NUCLEAR SAFETY RELATED

PTC 2200P EDP-35621B REV. 6
 DATE ISSUED 3-27-67
 TITLE OF DOCUMENT/SCHEMATIC DIAGRAM
 4160 VDC BUS 12EB
 LOAD SHEDDING STRINGS
 DOCUMENT TO BE REVISED:
 1-N-2572-18
 THE FOLLOWING IS ONLY USED FOR NEW DRAWINGS
 NSR NON-NOR INC. CODE
 PIS PS
 PREPARED BY: [Signature]
 CHECKED BY: [Signature]

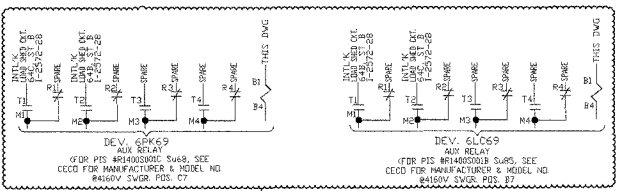
ADD PER
 EDP-35621
 REV. 6
